## Product Change Notice (PCN)

**PCN Number:** PCN-0456242R-02

Product(s) Affected: *SJ1-353XNS Series (SJ1-3533NS, SJ1-3534NS, SJ1-3535NS)*

Description of Change: *Minor Layout and Material Difference. See image Below*

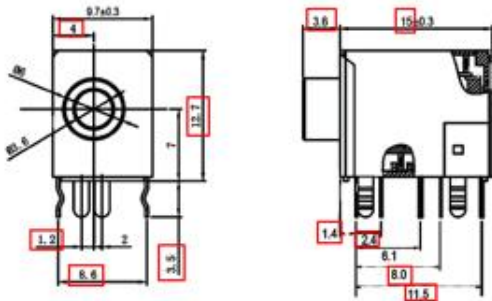
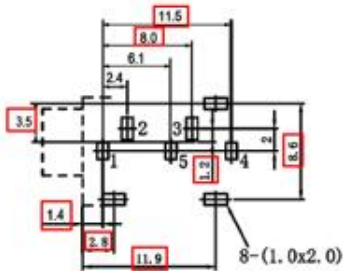
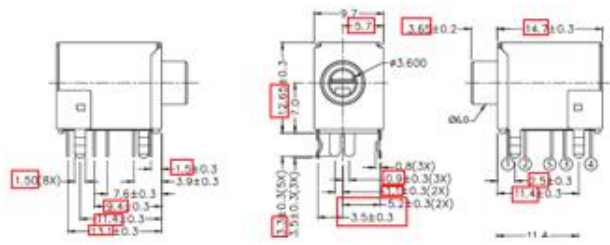
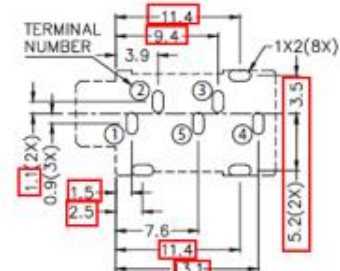
Reason(s) for Change: *Manufacturing Improvement processes*

DESCRIPTION	MATERIAL	PLATING/COLOR
terminal 1	brass	silver
terminal 2	phosphor bronze	silver
terminal 3	phosphor bronze	silver
terminal 4	brass	silver
terminal 5	brass	silver
spring	stainless steel	nickel
bushing	brass H58	nickel
shield	SPCC t=0.30	nickel
housing	PBT (UL94V-0)	black

DESCRIPTION	MATERIAL	PLATING/COLOR
terminal 1	brass	tin
terminal 2	brass	tin
terminal 3	brass	tin
terminal 4	brass	tin
terminal 5	brass	tin
spring	stainless steel	
bushing	brass	nickel
shield	cold rolled steel	nickel
housing	PBT (UL94V-0)	black
